Access Compliance Report

Public Rights-of-Way

Intersection ID: 6811	Main Street: ALTLIFF_CT	Cross Street: WINGDALE_DR	Location:	N
ADA ID: CF0FAA5E0565	Ramp Type: BlendTrans1	Initial Pass/Fail: Fail	Overall Compliance: No	Severity Score: 10

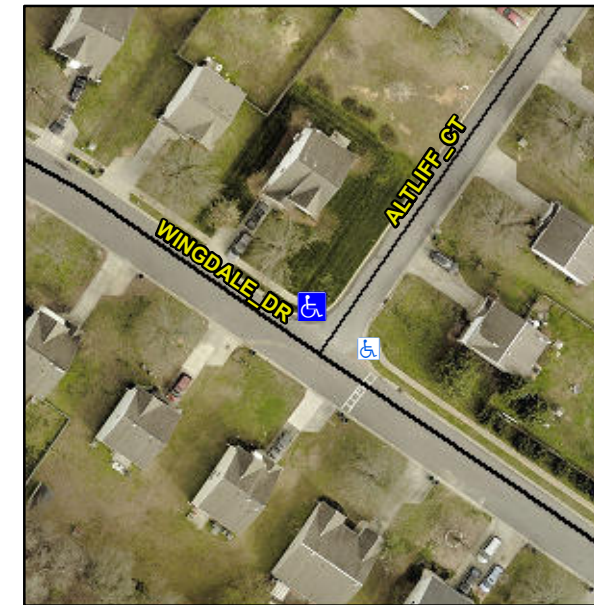
NO RT SW

Not Found, R304.5.1, R304.5.3

Compliance	Description	Data	Compliance	Description	Data
N/A	Ramp Length (in)	50.5	Yes	BlendTrans Slope (%)	3.8
No	Ramp Width (in)	37.5	No	BlendTrans XSlope (%)	4.2
N/A	Flare Type LT	N/A	N/A	Flare Type RT	N/A
N/A	Flare Slope LT (%)	N/A	N/A	Flare Slope RT (%)	N/A
N/A	Flare Traversable LT?	N/A	N/A	Flare Traversable RT?	N/A
N/A	Landing Length (in)	N/A	N/A	DWS Provided?	N/A
N/A	Landing Width (in)	N/A	N/A	DWS Contrast?	N/A
N/A	Landing Slope (%)	N/A	N/A	DWS Length (in)	N/A
N/A	Landing X Slope (%)	N/A	N/A	DWS Full Width?	N/A
N/A	Landing Curb? (Y/N)	N/A	N/A	DWS Offset (in)	N/A
N/A	Shared Landing?	N/A			
N/A	Gutter Ponding?	N/A	N/A	Gutter Slope (%)	N/A
N/A	Gutter Lip Ht (in)	N/A	N/A	Gutter X Slope (%)	N/A
N/A	Painted X Walk1?	No	N/A	Painted X Walk2?	N/A
	X Walk 1 Direction	To SE		X Walk 2 Direction	N/A
	X Walk 1 Width (in)	N/A		X Walk 2 Width (in)	N/A
	X Walk 1 Slope (%)	1.9		X Walk 2 Slope (%)	N/A
	X Walk 1 X Slope (%)	1.2		X Walk 2 X Slope (%)	N/A

N/A	Ramp inside XWalk1?	N/A	N/A	Ramp inside XWalk2?	N/A
	Road Slope (%)	1.2		Clear Space?	N/A
	Road X Slope (%)	1.9	N/A	Clear Space to XWalk (in)	N/A
N/A	Any Obstructions?	N/A	N/A	Storm Grate/Utility Hazard?	N/A
	Obstruction Type			Storm Grate/Utility Type	
		N/A			N/A
			Yes	Surface Condition? (G/P)	Good
			No	Curb Slope (%)	8.2

Remove & Replace Curb Ramp With Two New Directional Ramps or Equivalent.
